AMMENDMENTS TO CLAIMS

Title:: Tool and Notation for Capturing and Communicating Enterprise and Technology Structures, Processes, Strategies, and Concepts

Application Number: 10/602,566

remarks figure 1: from Nochur

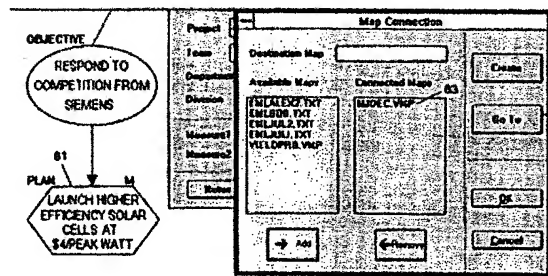
- b. Most modeling tools have objects or entities with attributes as does Nochur. Nochur uses traditional flowcharting symbols for the entity and pop-ups for the attributes. Nochur doesn't claim or have any invention in this area. My invention is in the way the information is presented. The difference in presentation is clear in remarks Figures 1&2 below. My claims 1 and 20 attempt to describe the uniqueness.

- Response to rejection of claim 14 on Pages 10-11 of the Office Action:
 1. The Oracle Component icon in remarks figure 2 is an example of claim 14. Michelle's comment is suggesting that Nochor line adornments such as the arrow head in remarks figure 1 above are the equivalent of claim 14. This must be a typo. Claim 14 talks about an element of my claim 1 shape. Nochor's relationship lines are not pertinent.

- Response to rejection of claim 15 on Page 11 of the Office Action:
 1. The M indicator in Nochor indicates there is an attached map. It does not indicate that the object is plural or a collection. For example in remarks figure 1 above, the M on the lower shape does not indicate that "LAUNCH EFFICIENCY SOLAR CELLS AT \$4/PER PEAK WATT" is plural. It says there is a Map pop-up.

remarks figure 2: from Sewell

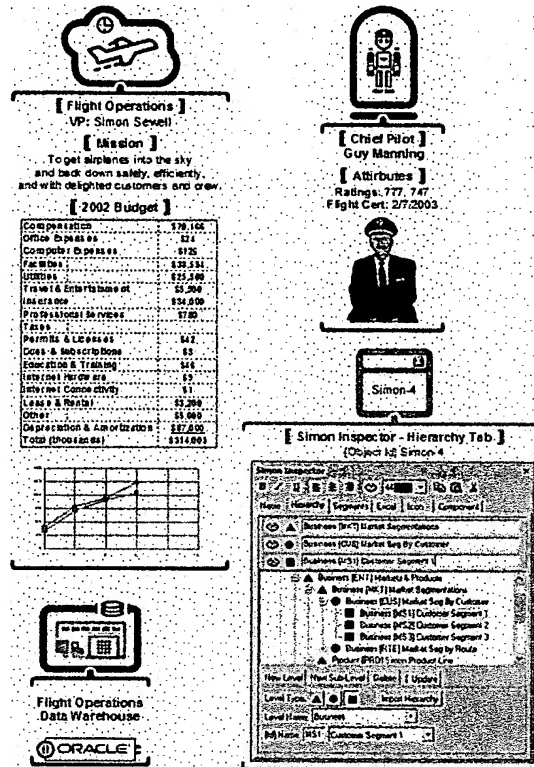
- h. Nochur pop-ups cannot contain graphics as required by my claim 20. Notice the picture of the pilot in remarks figure 2.
- i. Nochur shapes are not **predefined** with **predefined meanings** as required by my claim 1.

- j. Nochur either does not have either **predefined icons** or **predefined adornments**. In Michelle's arguments, she uses the same icon to for both. Nochur might have one (debatable) but it surely doesn't have two or more. Notice the clock and the pilot icon in remarks figure 2. Also, Michelle mistakenly considers a letter M adornment as an icon. One is text and the other is a graphic.
